Checking procedure and recommended lifetime of track rollers in rear hold down assembly

Technical Bulletin

TB5000-059

5000 Bodymaker

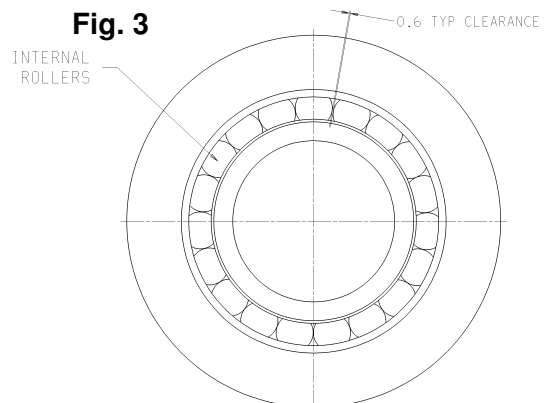
The track roller, part number 2006120B, is a wear item which requires periodic inspection and scheduled maintenance to monitor its condition so it can be replaced before failure. Catastrophic failure of the track roller may damage other parts of the machine. See Fig. 1

There should be 0.075 - 0.175mm clearance on each side of the track roller between the flanged bushes. This should be checked every six months with a feeler gauge to ensure there is not excessive clearance due to wear. If there is excessive clearance the track roller and/or flanged bushes may be worn and require replacing. See Fig. 1

It is also recommended the gaps between the nineteen internal rollers are checked, as excess clearance may allow the rollers to move out of position and seize the follower. When new the clearance is typically 0.6mm. This may change due to accumulation of tolerance. If the gap exceeds 2.5mm the track roller requires replacing. See Fig. 3
Unfortunately the cam lever inhibits access to the internal rollers so it is necessary to remove the track rollers to inspect the clearance.

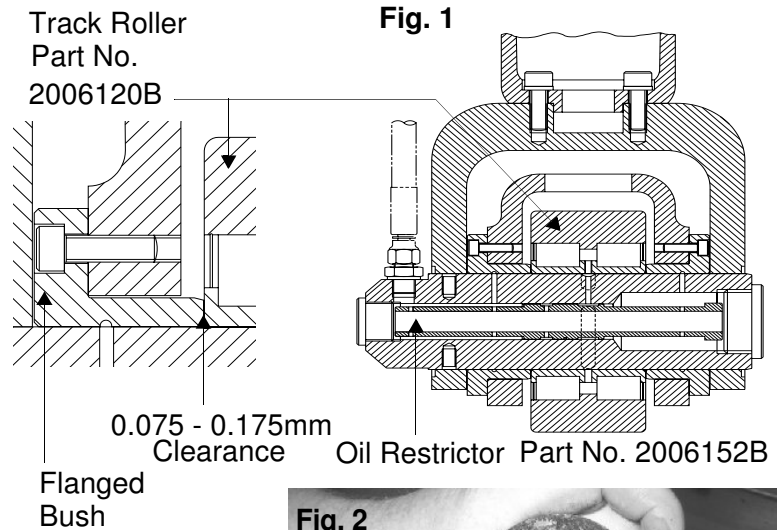
The track roller is fed with oil through the Oil Restrictor, Part number 2006152B. Depending on the condition of the oil, contamination can accumulate in the Oil Restrictor and reduce the flow of oil that lubricates the track rollers. Every six months the Oil Restrictor should be removed and cleaned to remove any contamination and clear all oil ways. The Oil Restrictor should be cleaned every time the track roller is replaced. See Fig. 2
